## Report to the Future Melbourne Committee

**Planning Permit Application: TP-2021-245**  
**47 Arnold Street, South Yarra**

**19 October 2021**

## DELEGATE REPORT

Figure 10 – Extract of proposed ground floor plan (Source: applicant)

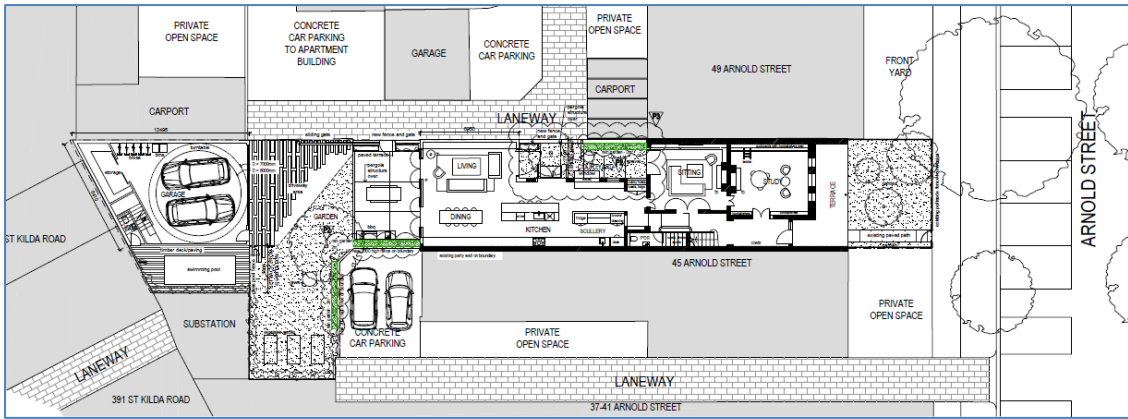
*The location of each raingarden must also be included on the ground floor plan of the planning drawings, including a notation showing the surface area of each one. This could be required via condition 1.*

*Provided that the raingarden details as shown on page 9 of the WSUD report are included on an updated ground floor plan, the proposal is acceptable.'*

- a. Dimensioning the height of the pergola element to the north side courtyard, to the satisfaction of the responsible authority.
  - b. The location of each raingarden detailed in the WSUD report prepared by Urban Leaf (dated 4 June 2021, Rev A) must be included on the ground floor plan, including a notation showing the surface area of each one. The proposed location and size of each raingarden is as follows (or as otherwise required by the WSUD report):

Figure 14 – mark-ups from the heritage advisor (Source: Council)

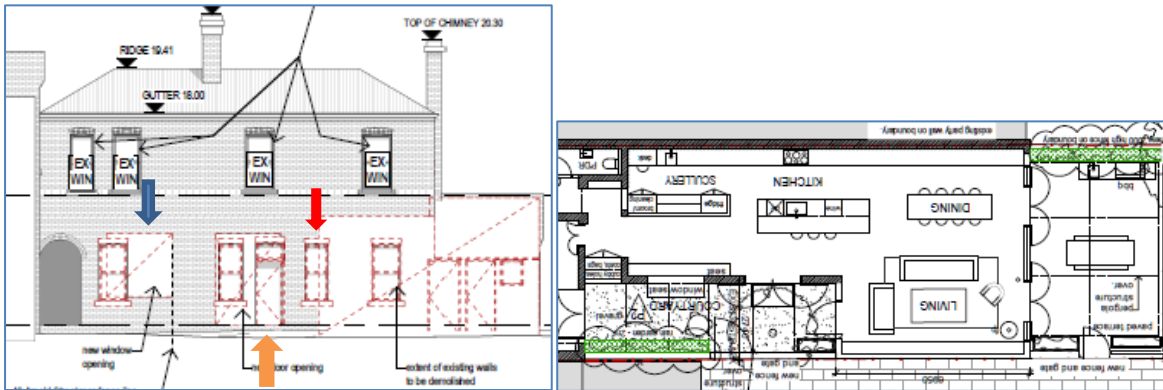
*'The proposal is supported with the following modifications:*

- 1. Adjust the location of the ground floor addition to enable the retention of the window arrowed red in Figure 1, plus at least 110mm of wall to the west of the window.*
- 2. Retain all existing windows and the door to the ground floor, north elevation, except for the western window.*
- 3. A new window could be inserted at the blue arrow indicated on Figure 1, head aligned with the adjoining and size similar to the western window scheduled for removal in item 2.*
- 4. Adjust the height of the proposed CL 1292 fence to be no taller than the existing. Annotate the existing height on the drawings.'*

In response to the concerns with the extent of demolition, the applicant lodged a s.57a amended plans (see **Figure 16 and 17**) which retained the furthest east ground floor window as well as lowering the height of the boundary fence (to the north laneway) to match the existing. These changes result in further heritage retention and maintain the view to the host building and are acceptable.

Figure 16 – extract of the proposed north elevation (Source: applicant; note by Council).

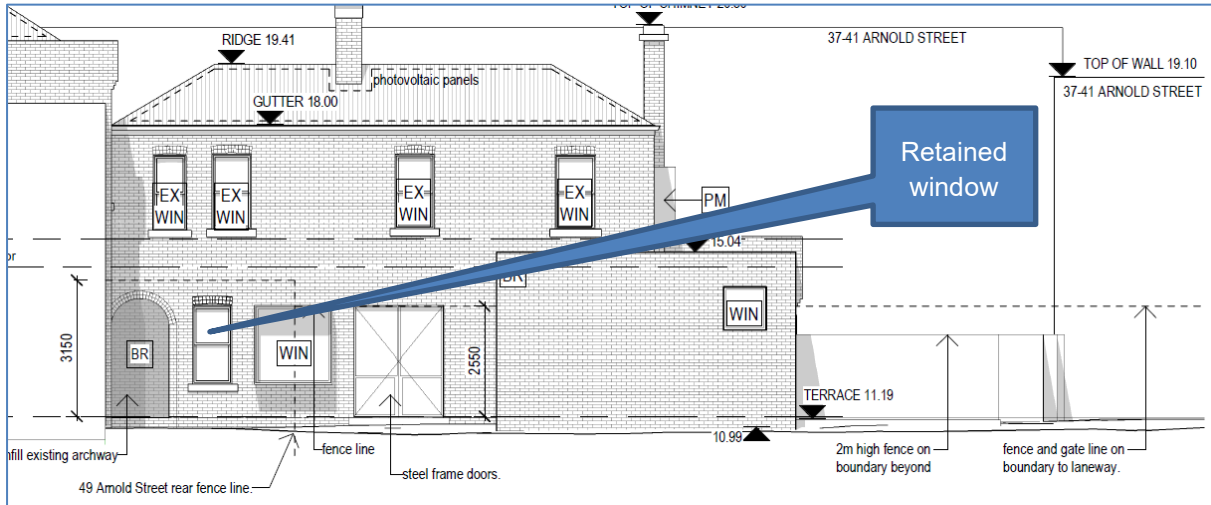
In reference to **Figure 15** below the side windows are largely obscured from the public realm. Some oblique views are available from Bromby Street to the north. Council's heritage advisor has suggested that more of the ground floor north elevation windows should be retained.
